REVISED SHEET 4/10/2025

**MCDONOUGH AND BRANDON STREET
 SUMMARY OF QUANTITIES**

F.A.U. RTE.	SECTION	COUNTY	TOTAL SHEETS	SHEET NO.
	(1981-082B-I) BR 24	WILL	30	3
			CONTRACT NO. 62X93	
		ILLINOIS FED. AID PROJECT

**MCDONOUGH AND BRANDON STREET
SUMMARY OF QUANTITIES**

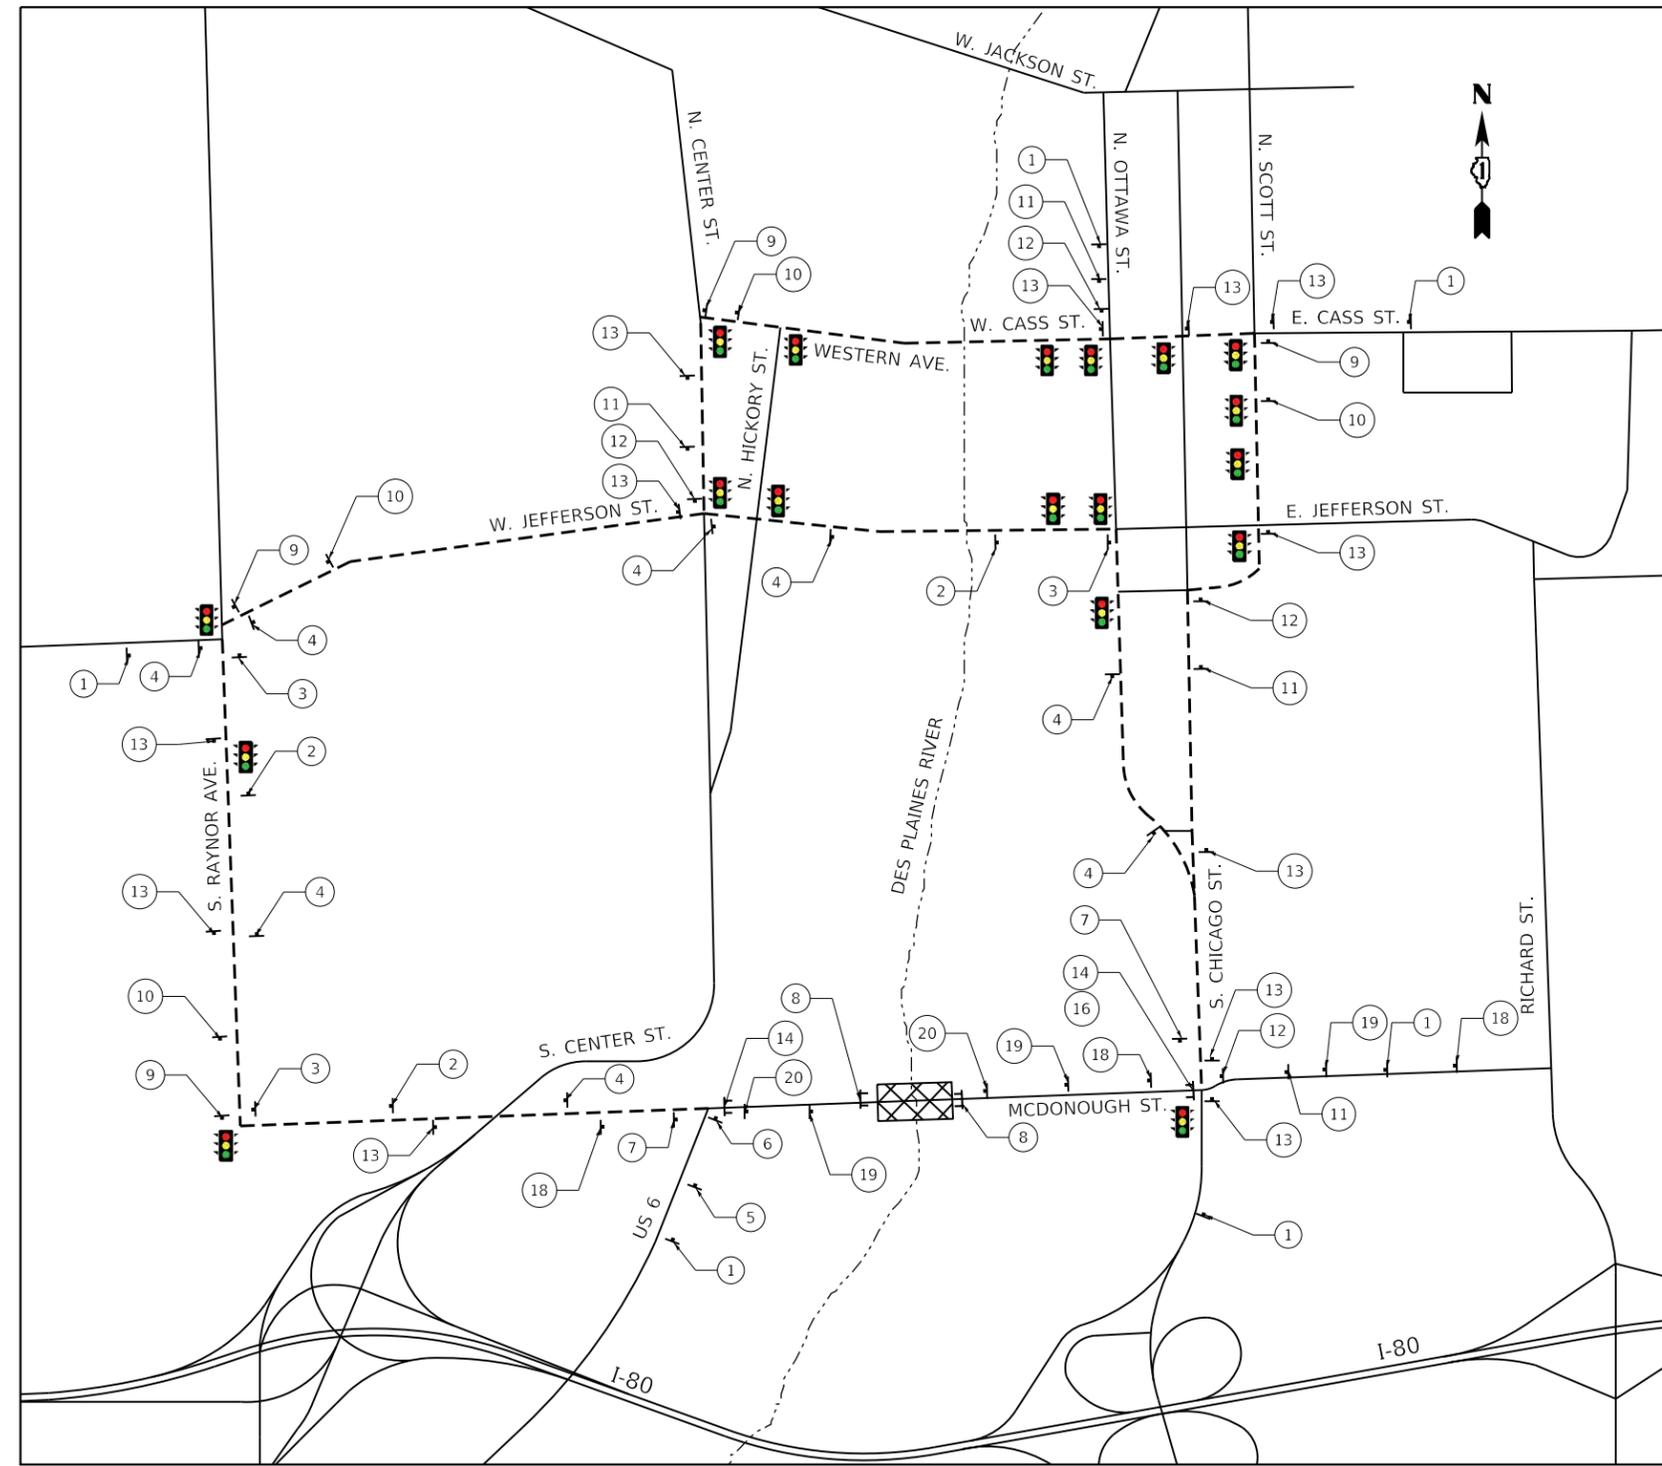
REVISED ENTIRE SHEET 4/10/2025

**MCDONOUGH STREET (US 6/US 52)
CAR DETOUR PLAN**

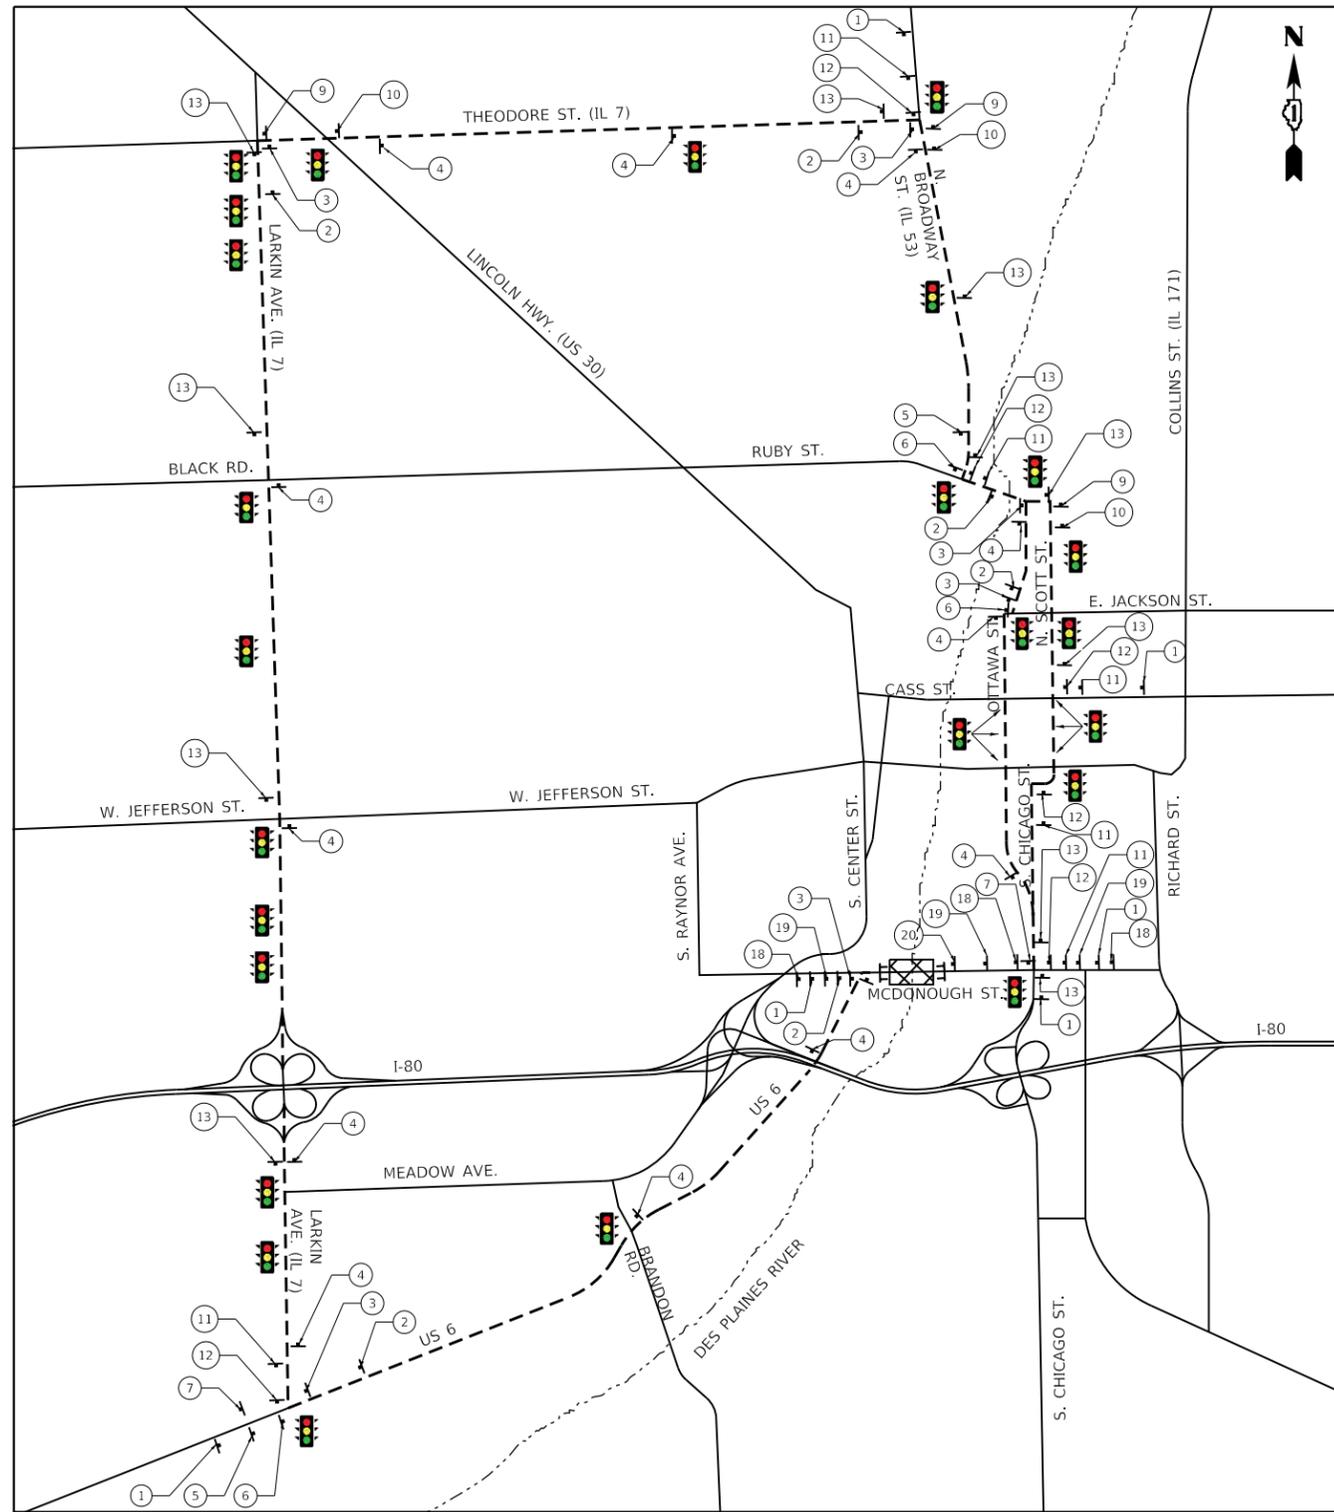
REVISED ENTIRE SHEET 4/10/2025
